Product Change Notification

PCN-PCC-9847-2024

Business Unit	Product Line Code	Type of Change	Action	Date of Issue
PCC - PCB Connectors	AAA	Product Change Notification	Notify Distributors and Field	5/7/2024

Previous Product		New Product	
ALT/ OLD  		NEU/NEW  	
ALT/OLD  		NEU/NEW

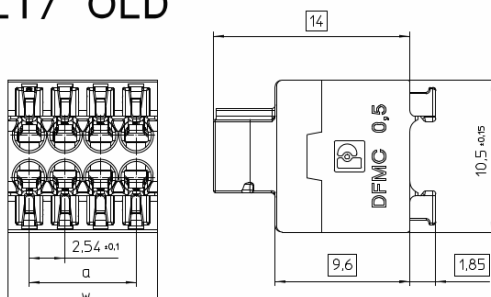
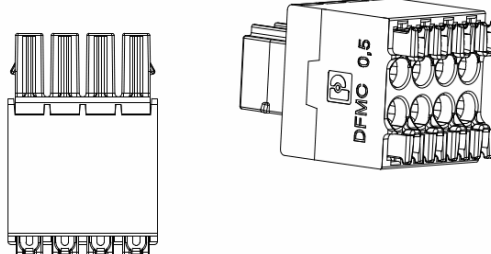
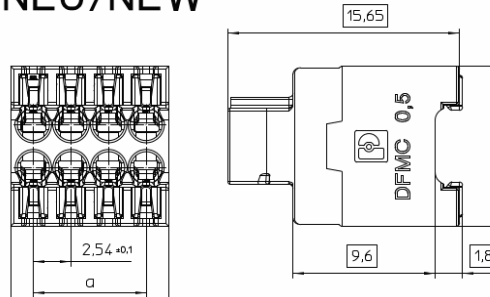
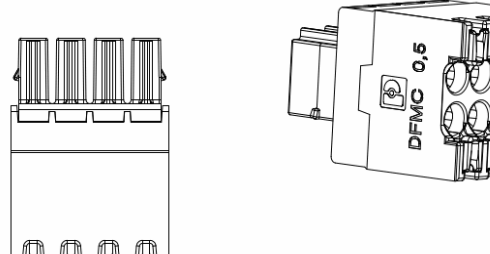
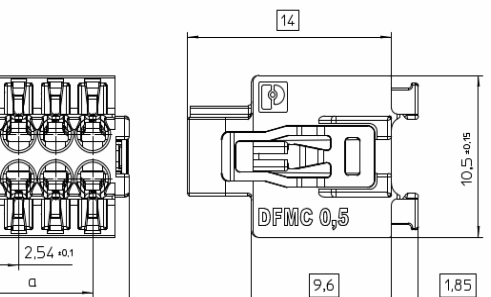
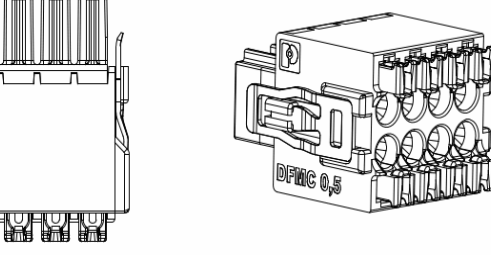
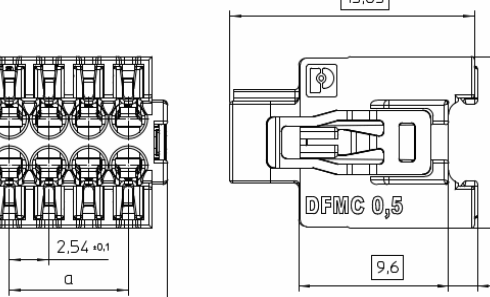
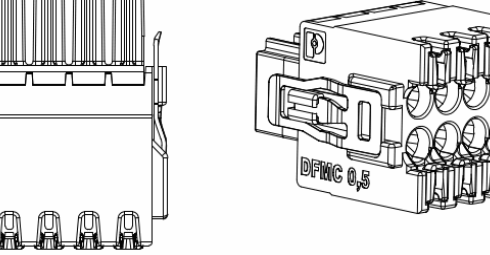
The upper part of the connector is extended in the area of the spring levers. The technical data of these connectors do not change. The difference can be seen in the drawings within this PCN.
